Technical change to passive M12 Distribution Boxes with fixed cable outlet

the products of M12 Distribution Boxes with Fixed cable outlet will be changed after a transitional period. Please pass on this Product Change Notification (PCN) to your employees and, if applicable, to your customers.

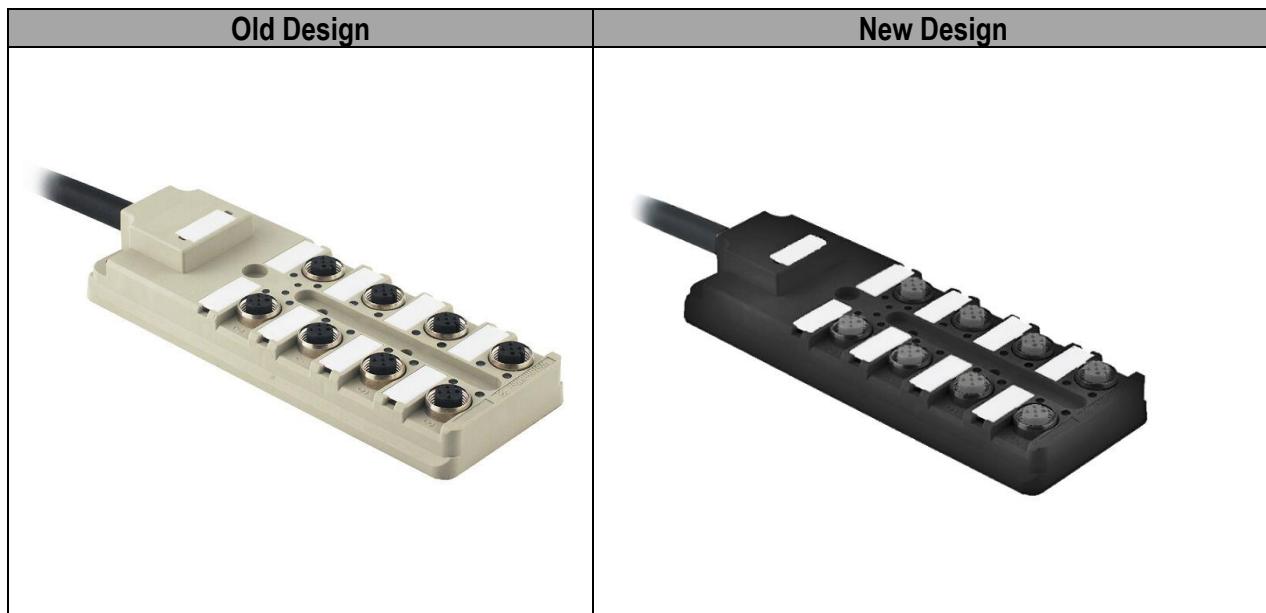
- Change to Lead free Components
- Change of Potting and the Color of the Housing
- Removal of Protection Caps and Markers
- Change of the Designation to new Designation Key
